## CLEARFIELD CITY PLANNING COMMISSION MEETING AGENDA

# Planning Commission STAFF REPORT

SUBJECT: Discussion and Possible Action on SP 2025-0601, a site plan request by Design

Project Information
Project Name	Monument Motors
Site Location	460 West 1700 South
Tax ID Number	12-065-0203
Applicant	Design West Architects
Owners	Lundock Deets LLC
Proposed Actions	Site Plan Approval
Current Zoning	C-2 (Commercial)
General Plan Land Use Classification	Commercial
Gross Site	1.87 Acres

SITE PLAN

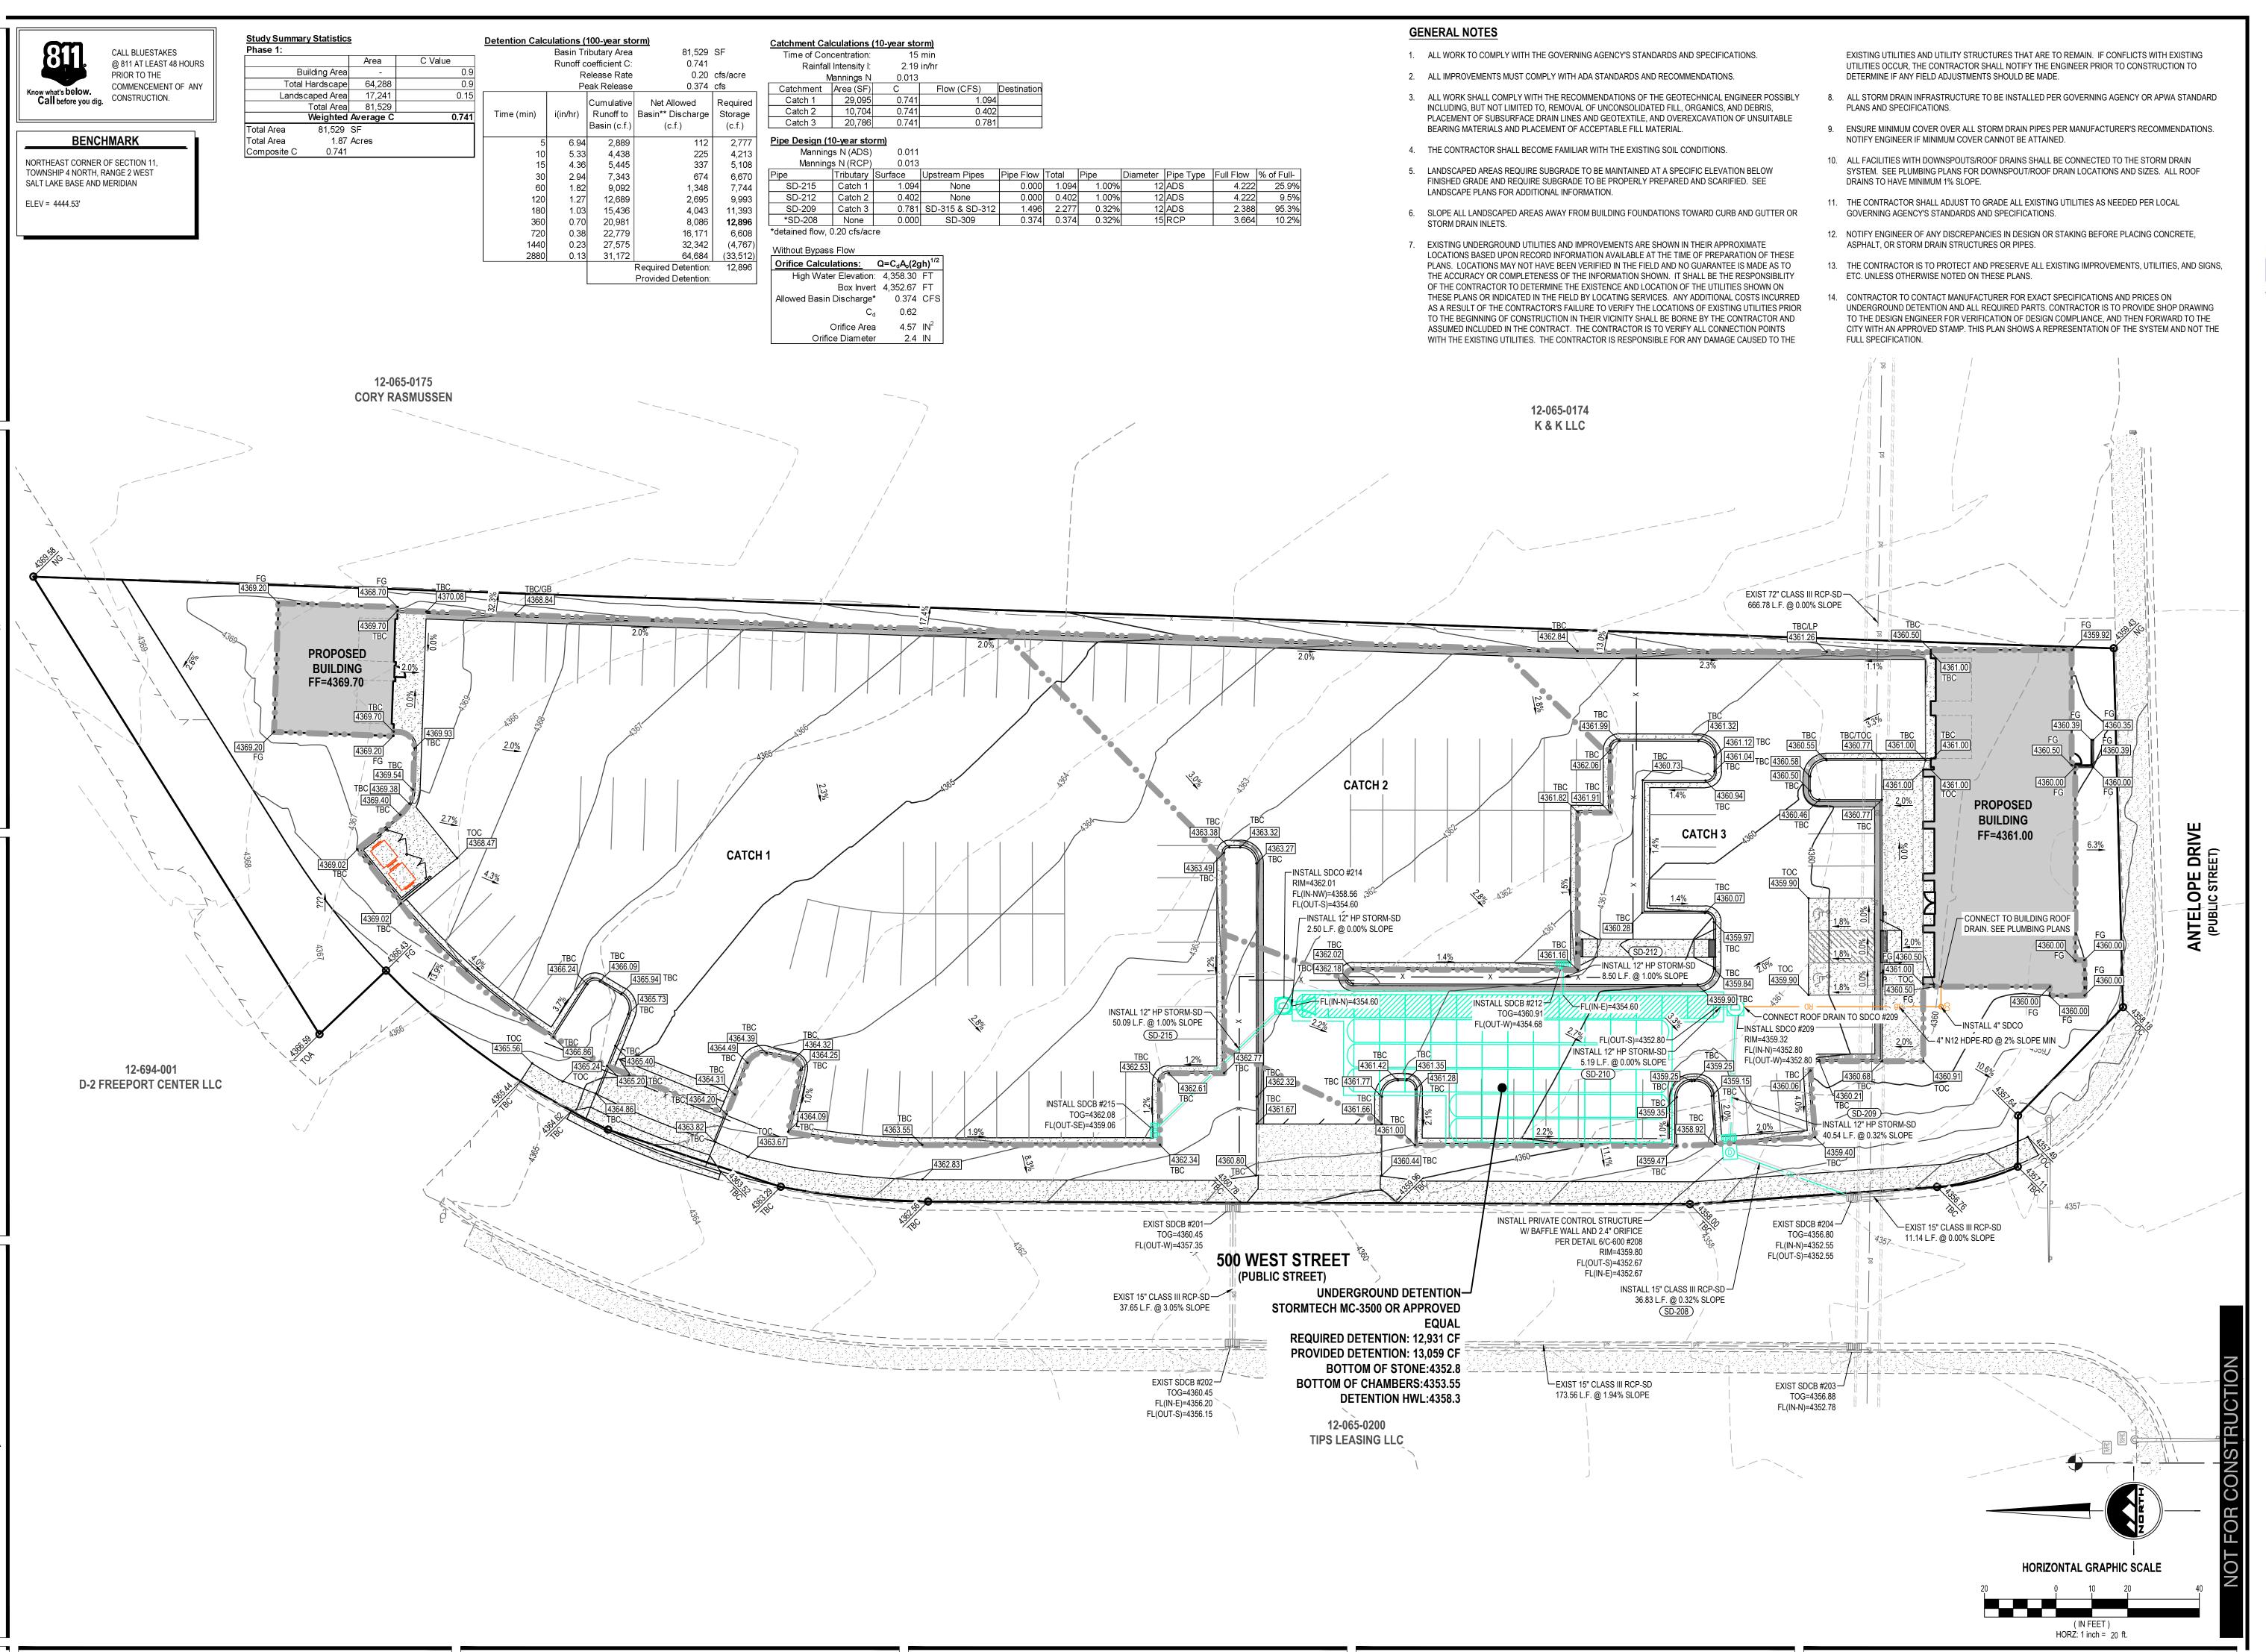
Parking lot designs are required to plan for snow stacking areas. The site plan will need to indicate where the snow will be stacked onsite.

- The plans will need to be updated to provide pedestrian access from the public sidewalk to the main entrance of the building. This can be accomplished with a direct connection from the proposed sidewalk to the concrete landing in front of the main entrance, or a connection at the point of vehicular access to the customer parking lot.

**UTILITY PLAN**

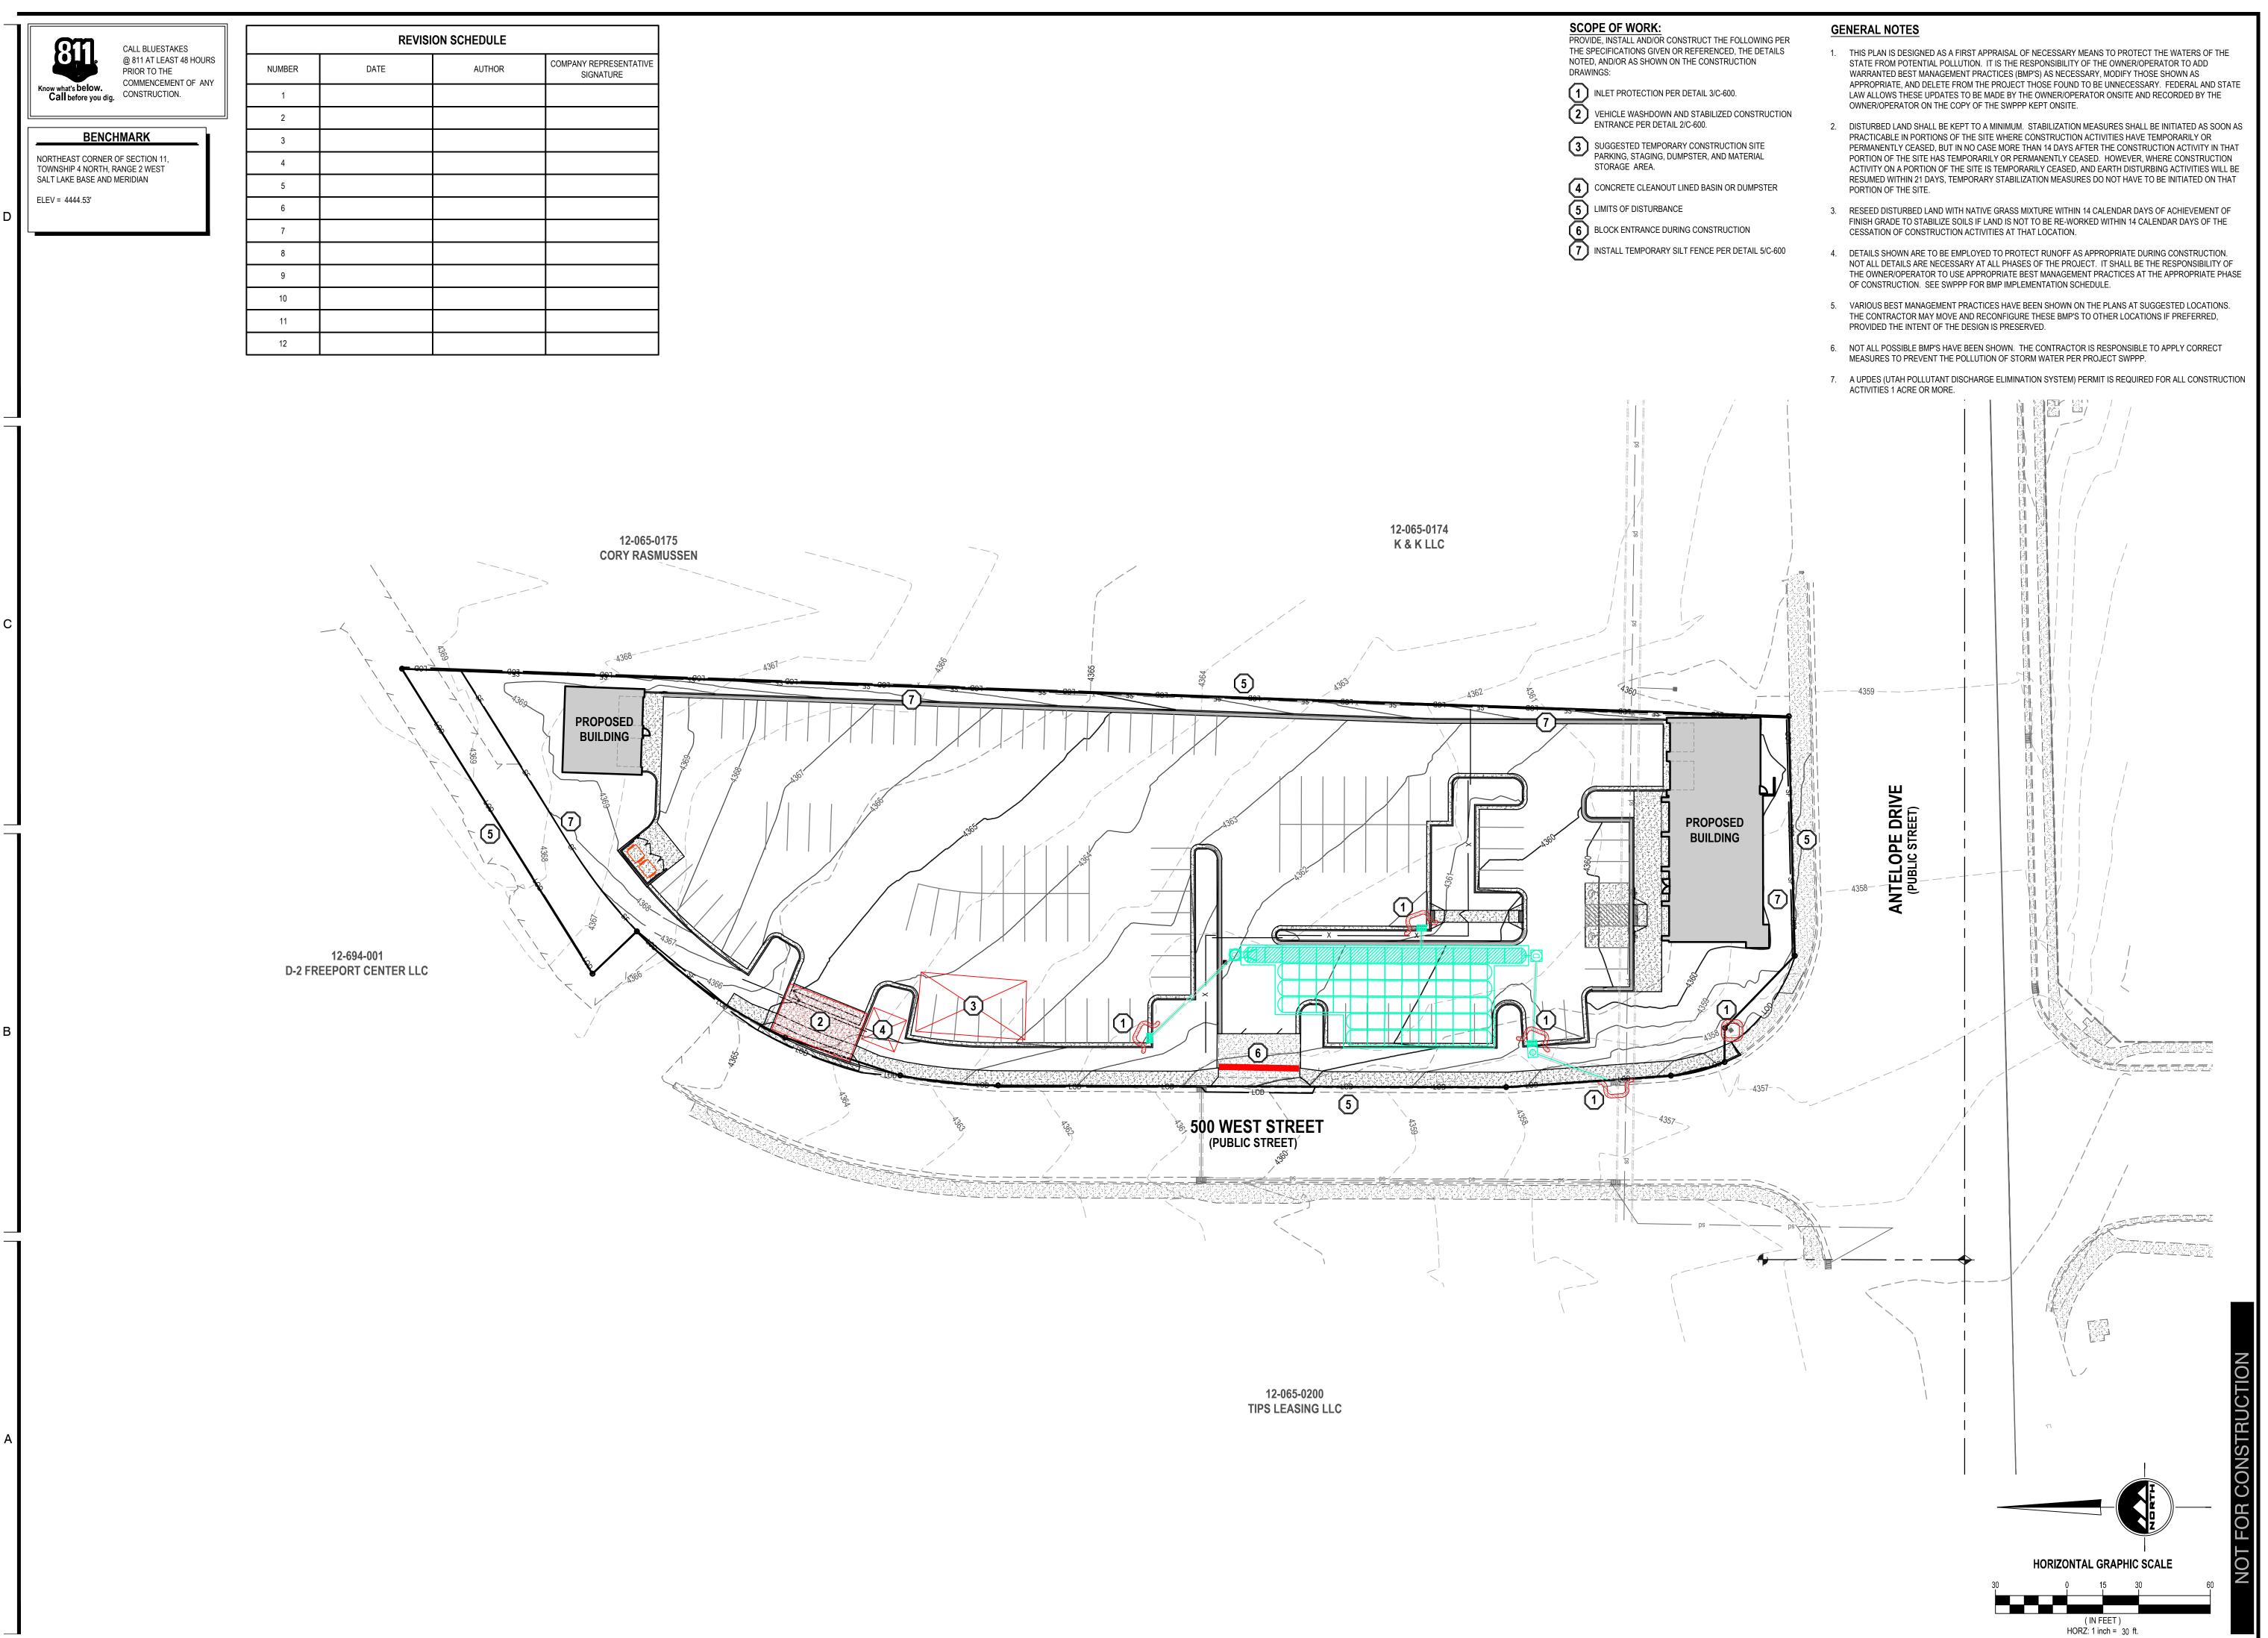
The irrigation plan meets the water efficiency standards of our code. The landscaping will require a separate water meter which is not shown on the plans. Staff recommends that the applicant review the civil utility plans, and locate the water meter and backflow device toward the rear of the property where the culinary connection is planned.

- 2) The utility and irrigation plans shall be updated to show the separate connection and water meter for irrigation.
- 3) The site plan shall be revised to designate a snow stacking area that complies with ordinance standards as outlined in Chapter 14 of the Land Use Ordinance.
